NAACA-PNM Meeting Minutes
12/3/24 Sandia Presbyterian Church- Sunrise Chapel

PNM Slideshow Presentation. Looking to site substation in NAA. On or near Paseo del Norte between Ventura and Tramway. Area is growing in NAA and the way “we” use energy is changing. Timeline of project. Currently in public input stage. Application planning to be submitted in Spring 2025. Expect to begin construction Summer 2026. Showed preferences of site locations according to “voting.”

Potential Sites for Proposed North ABQ Acres Substation

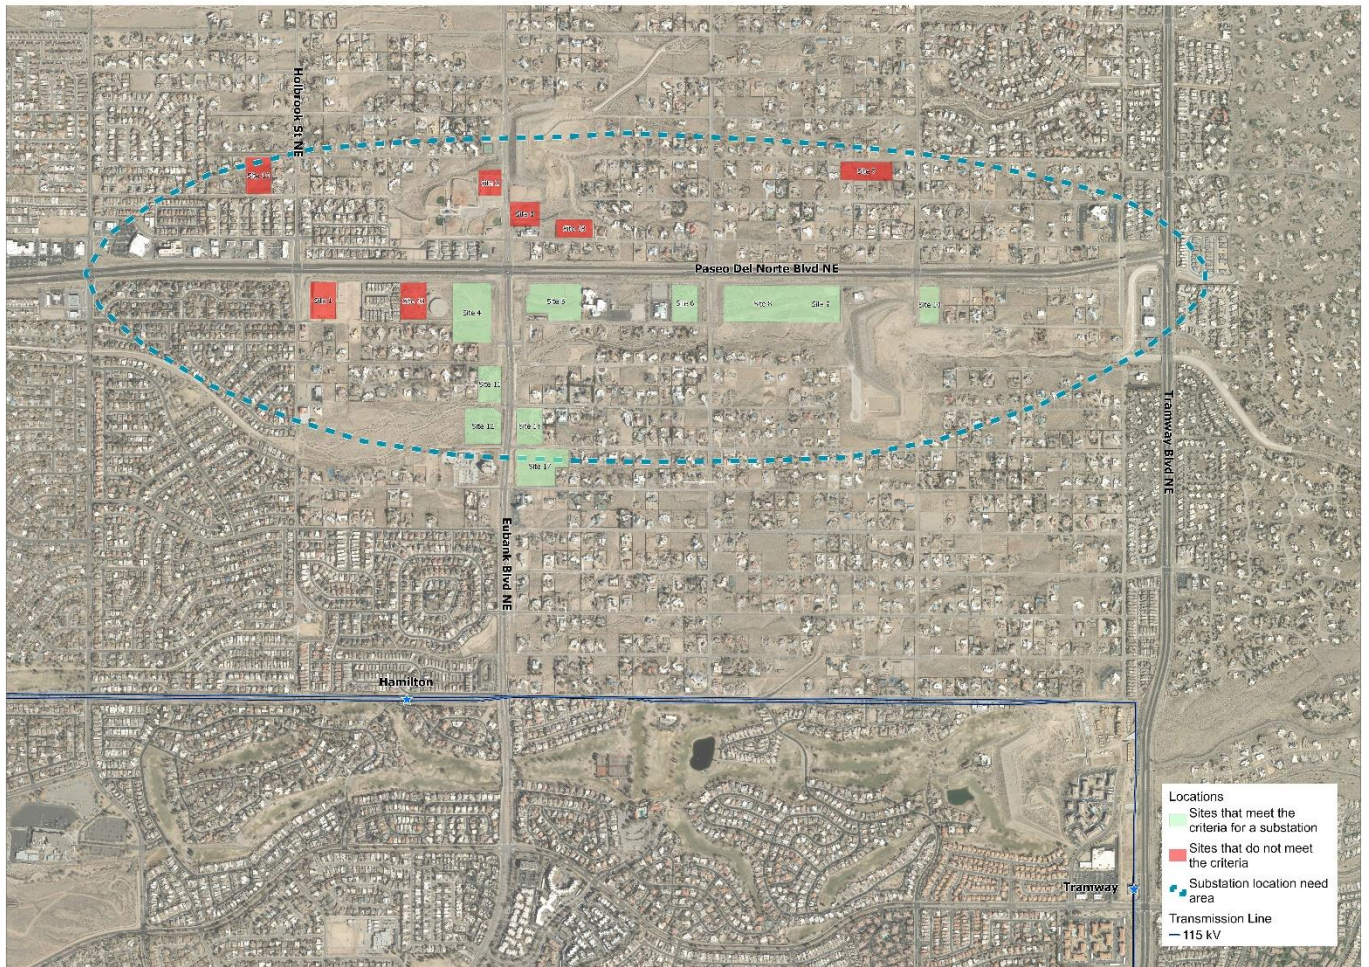
Question about priority of lots. Sites by school & church less favorable. Saying #4 is more favorable because water reservoir tank. PNM currently owns a small parcel of site #4, but favorable are #9, #10.

Question why some proposed sites have homes on them (eg, site #16). PNM says that sites will be reevaluated and that they used satellite maps to show potential sites.
